PRODUCT UPDATE

Written by | PRODUCT & APPLICATIONS | August 7, 2018 | #202

ERN Model - S Series
Standardization of Grounding Tag Position

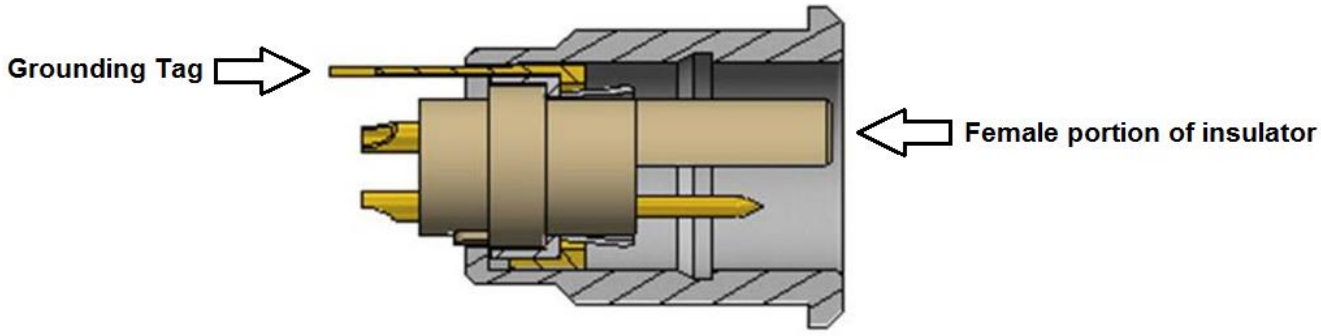
The orientation of the grounding tag for the ERN model has been standardized.

The grounding tag orientation for the ERN model in the 0S, 1S, 2S and 3S Series is becoming standardized and will be located 'in-line' with the female portion of the insulator with solder and crimp contacts as shown in the attached sketch (below). Legacy product, depending on size, wasn't always located in the same position. The ground wire length may need to be adapted to accommodate this change.

This change affects both metal and plastic versions of the ERN model.

Printed Circuit Board (CLN suffix) and other specialty types with suffixes such as CLNY or CLNW will not be affected.
